# Access Compliance Report

## Public Rights-of-Way

### (Curb Ramps)

Intersection ID: 8113	Main Street: ORR_RD	Cross Street: GRIER_RD	Location: S
ADA ID: 57B308319653	Ramp Type: Perp	Initial Pass/Fail: Fail	Overall Compliance: No
Severity Score: 21.25			
Codes/Mitigation Info/Possible Solution		Field Measurements/Component Compliance

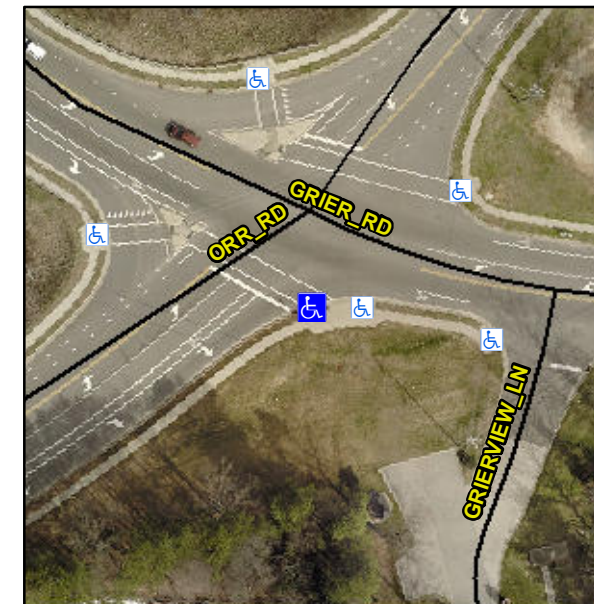
**Not Found, R304.5.1, R304.2.2**

Compliance	Description	Data	Compliance	Description	Data
N/A	Ramp Length (in)	47.0	No	Ramp Slope (%)	9.9
No	Ramp Width (in)	47.5	Yes	Ramp XSlope (%)	1.0
N/A	Flare Type LT	N/A	N/A	Flare Type RT	N/A
N/A	Flare Slope LT (%)	N/A	N/A	Flare Slope RT (%)	N/A
N/A	Flare Traversable LT?	N/A	N/A	Flare Traversable RT?	N/A
N/A	Landing Length (in)	N/A	N/A	DWS Provided?	N/A
N/A	Landing Width (in)	N/A	N/A	DWS Contrast?	N/A
N/A	Landing Slope (%)	N/A	N/A	DWS Length (in)	N/A
N/A	Landing X Slope (%)	N/A	N/A	DWS Full Width?	N/A
N/A	Landing Curb? (Y/N)	N/A	N/A	DWS Offset (in)	N/A
N/A	Shared Landing?	N/A			
N/A	Gutter Ponding?	N/A	N/A	Gutter Slope (%)	N/A
N/A	Gutter Lip Ht (in)	N/A	N/A	Gutter X Slope (%)	N/A
N/A	Painted X Walk1?	Yes	N/A	Painted X Walk2?	N/A
	X Walk 1 Direction	To NW		X Walk 2 Direction	N/A
N/A	X Walk 1 Width (in)	117.0	N/A	X Walk 2 Width (in)	N/A
	X Walk 1 Slope (%)	0.0		X Walk 2 Slope (%)	N/A
	X Walk 1 X Slope (%)	1.6		X Walk 2 X Slope (%)	N/A

**Remove & Replace Entire Ramp.**
